ADDENDUM NO. 4

PROJECT NAME: Textile Design Studio Renovation
UNL PROJECT NUMBER: A075P003
BID INVITATION NO.: 2050-12-7200

DATE OF ISSUANCE: January 30, 2013

FIRST FLOOR NEW PLAN- HVAC (ALTERNATE 2)

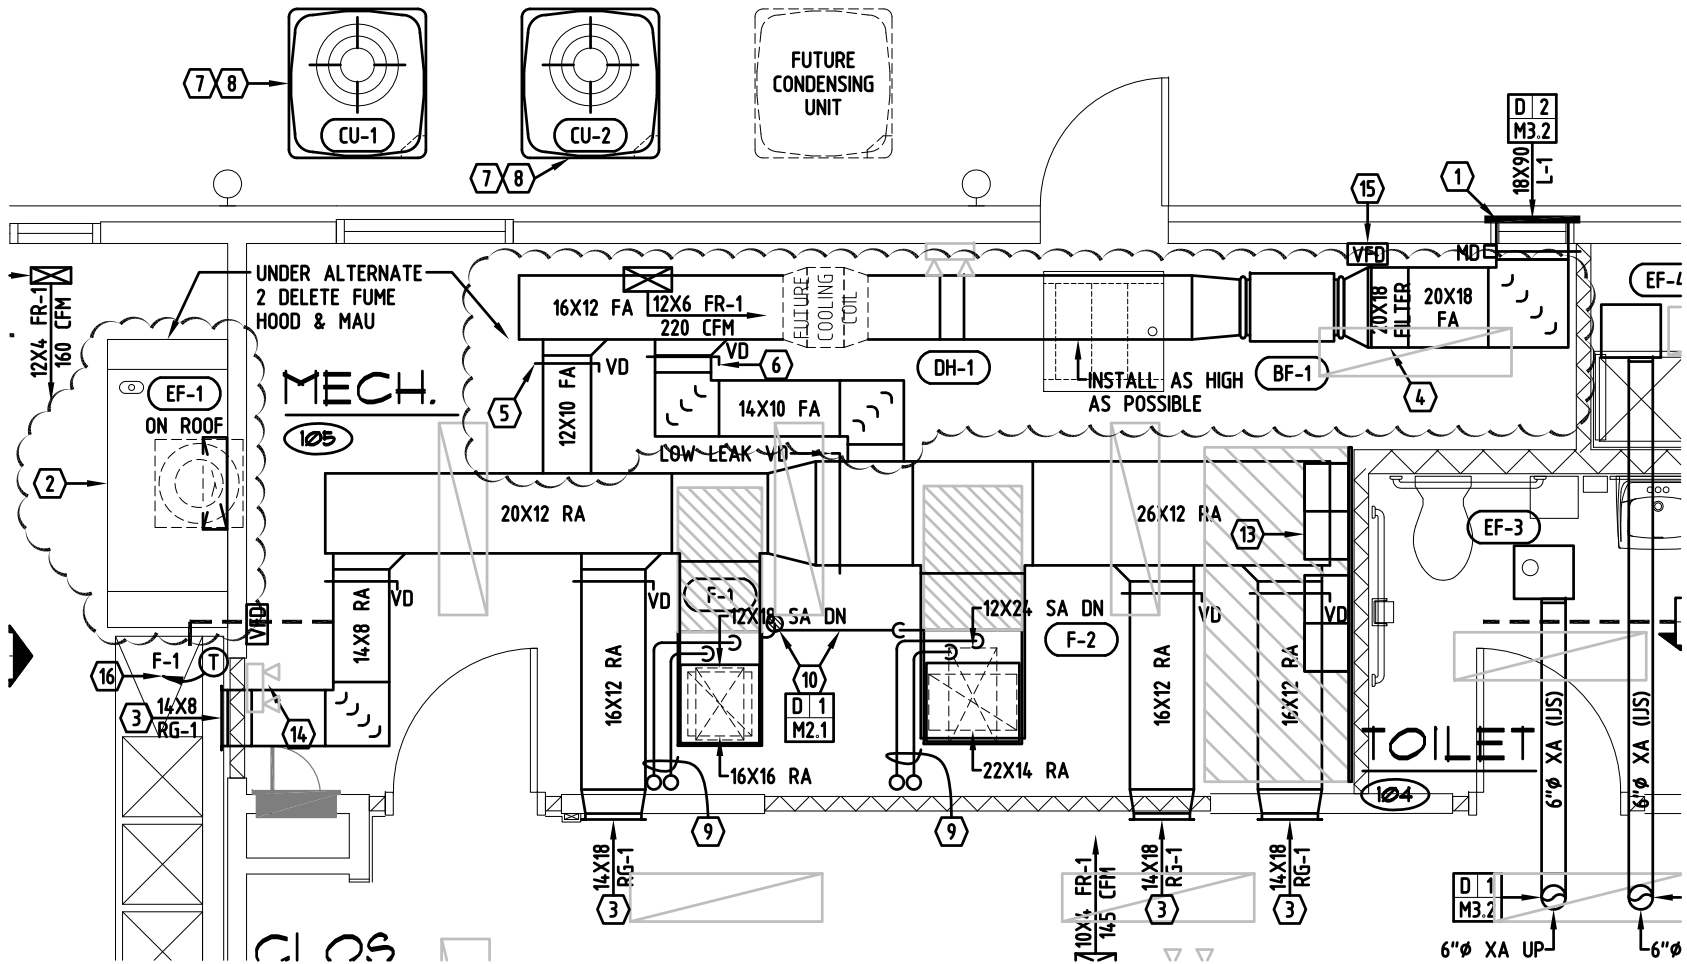
1. Under alternate 2, delete fume hood and fume hood exhaust fan (EF-1), electric duct heater (DH-1), booster fan (BF-1) and fresh air duct as shown on attached drawing. Provide 18"x90" louver (L-1) and mechanical damper as shown on original drawings and extend 8" diameter fresh air duct from louver to furnace (F-1) and balance to 110 cfm. Extend 10" diameter fresh air duct from louver to furnace (F-2) and balance to 265 cfm. See attached drawing. Clarification: The Owner can accept either Alternate No. 1 or Alternate No. 2 but not both of these alternates.
